Petition Number: 2017-097

From:	Kelsie Anderson, PE Kelsie.Anderson@charlottenc.gov 704-432-5492	Reviewer:	Carlos Alzate calzate@charlottenc.gov 704-432-0672		
	Revision Log:	Date		Description	
		07-20-17		First Review	
		01-23-18		Second Review

General Review Information

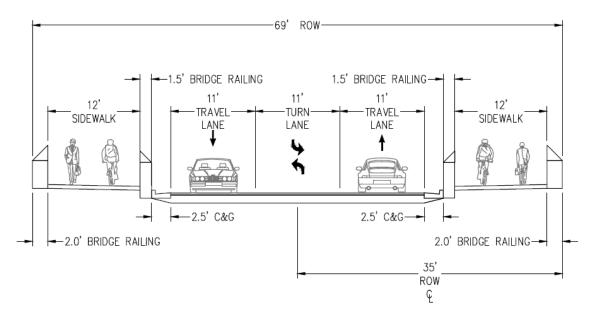
- 3. The petitioner should revise the site plan to show 2.5 foot curb and gutter, 8 foot planting strip and 6 foot sidewalk on existing Shopton Rd. The back of curb location is 41 feet from centerline of Shopton Rd.
- 4. The Coffey Creek bridge on Shopton Rd is to be replaced as part of a CNIP project. Street improvements should tie in to anticipated cross section below. Contact Felix Obregon at 704-432-5729 to discuss project specifics and coordination, as needed.
